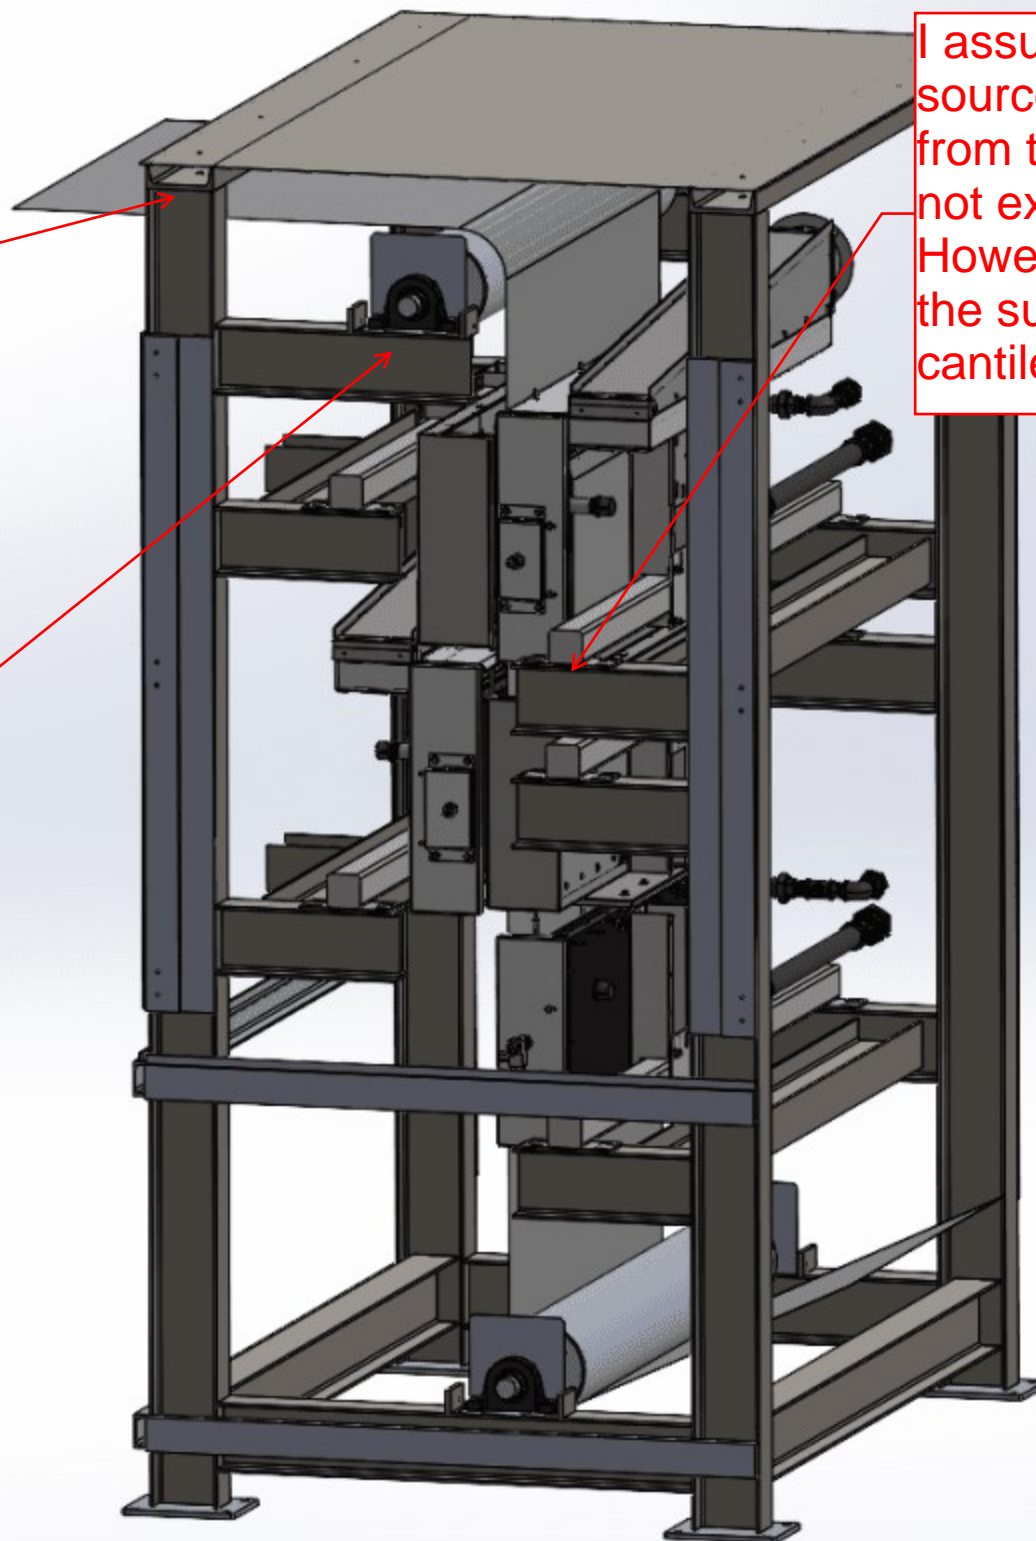
There will not be a lot of stability in the transverse direction. If that is a concern you could make a larger cross beam and/or add some diagonal bracing.

Extend to other side, cantilever will deflect.

I assume this is the heat source. If so it looks pretty far from the structure so I would not expect a lot of problems. However I would try to extend the support and not have a cantilever.
